SERVICE BULLETIN

Subject: New Kibes RT Updated Software and Implementing Freewheeling Diodes for Mux-5B Bulletin

Bulletin No: TS35-FM-2401

Vehicle Model: TS35

Diode Implementation

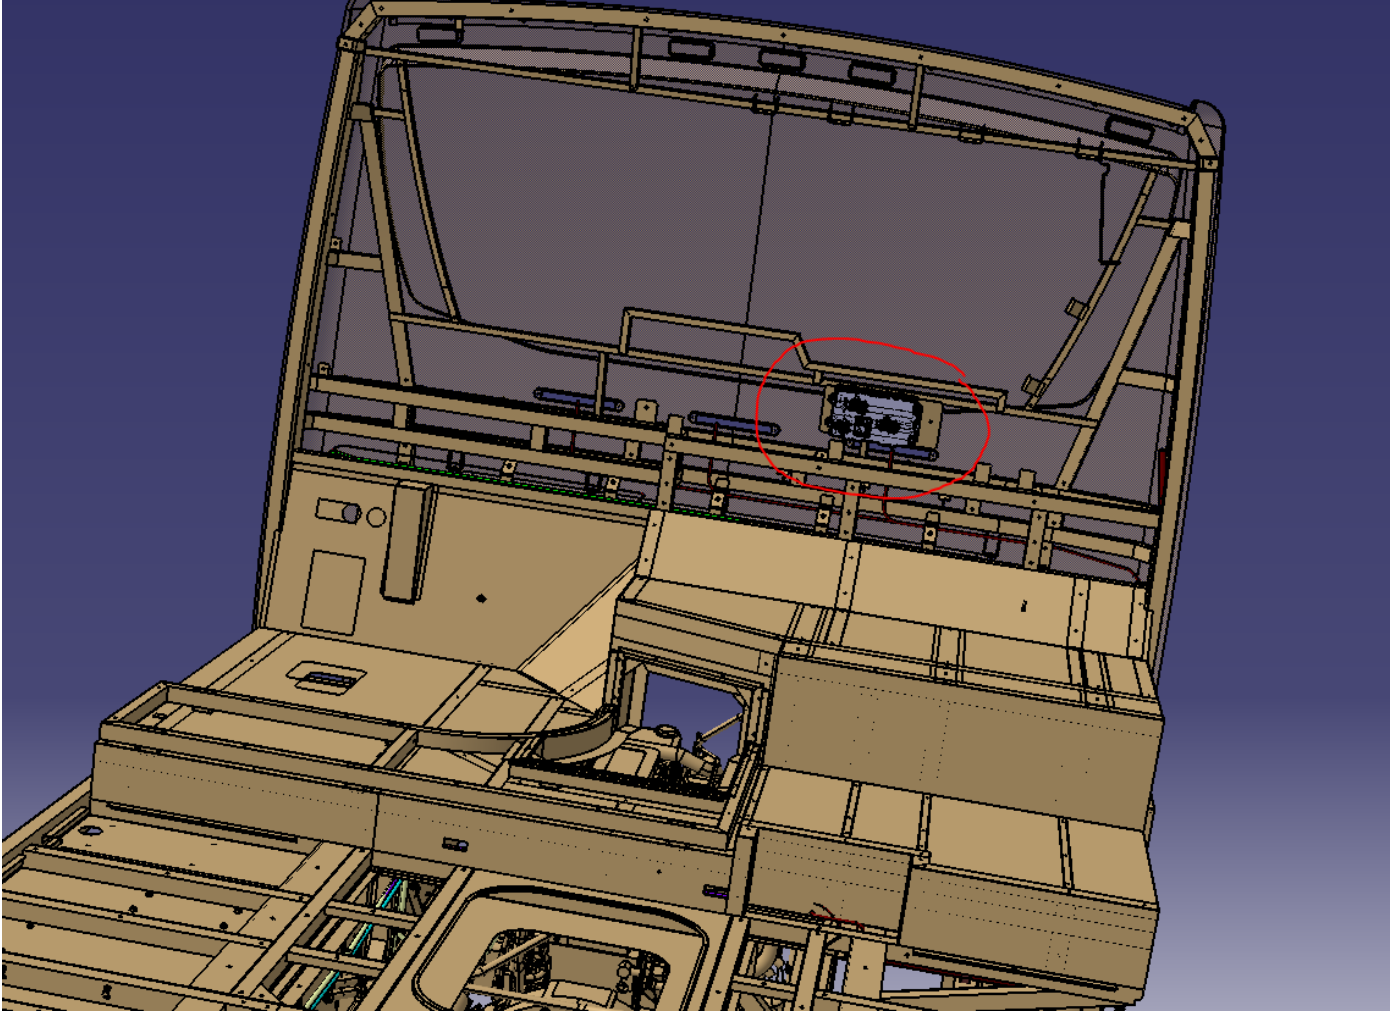
This bulletin includes the updated RT Kibes ZR5-A software. It will improve Multiplexing units' performance. Also, additional improvements were added to new Multiviu software. Freewheeling diodes will be implemented to the "Mux 1.1" and "Mux 2.1".

- 1-Open the front relay panel.
- 2-Locate the MUX5-B 1.1 Which is numbered as 06A033.

- 3-Locate the connector numbered P06A033-B
- 4- To its 15th and 16th pins do the operation explained below.
 - 1-Strip the cable from its 5 cm away from the connector side.
 - 2- Connect the diode's cathode pin to striped part of the cable.
 - 3- Connect the diode's anode pin to nearest ground cable.

- 5- Remove the back headlining which is at the back of the vehicle
- 6- Locate the MUX5-B 2.1 Which is numbered as 06A037.

- 7- Locate the connector numbered as P06A037-C
- 8- To its 21st pin do the operation explained below.
 - 1-Strip the cable from its 5 cm away from the connector side.
 - 2- Connect the diode's cathode pin to striped part of the cable.
 - 3- Connect the diode's anode pin to nearest ground cable.
